Z-90  
(2015)

# Z-90

**APPLICANT:** David Pearson Communities, Inc.

**ZONING COMMENTS:**

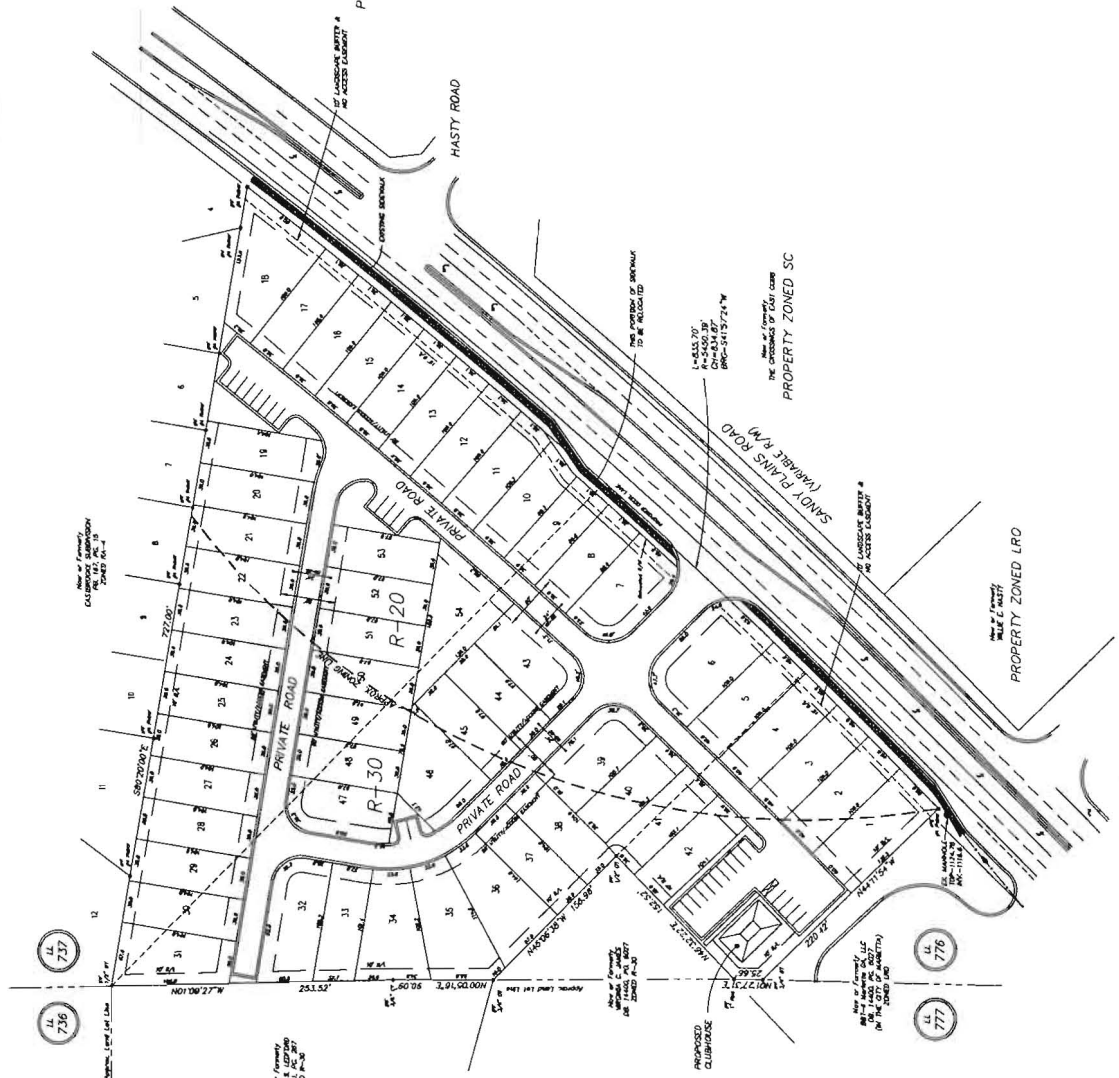
- Provide comprehensive hydrology/stormwater controls to include development of out parcels.
- Submit all proposed site improvements to Plan Review.
- Any **spring activity** uncovered must be addressed by a qualified geotechnical engineer (PE).
- Structural fill \_\_\_\_\_ must be placed under the direction of a qualified registered Georgia geotechnical engineer (PE).
- Existing facility.
- Project must comply with the Water Quality requirements of the CWA-NPDES-NPS Permit and County Water Quality Ordinance.
- Water Quality/Quantity contributions of the existing lake/pond on site must be continued as baseline conditions into proposed project.
- Calculate and provide % impervious of project site.
- Revisit design; reduce pavement area to reduce runoff and pollution.

- No Stormwater controls shown \_\_\_\_\_
- Copy of survey is not current – Additional comments may be forthcoming when current site conditions are exposed.
- No site improvements showing on exhibit.

1. The majority of the site drains to the west through existing residential parcels. There does not appear to be any well-defined conveyance through these parcels or any existing culvert under Ross Road. This issue will need to be addressed at Plan Review. The northeast corner of the site (approximately 1.3 acres) drains to the Sandy Plains Road Right-of-Way.
2. The developer is proposing the use of private roads which will require that all stormwater infrastructure be private as well and maintained by a mandatory home-owners association.
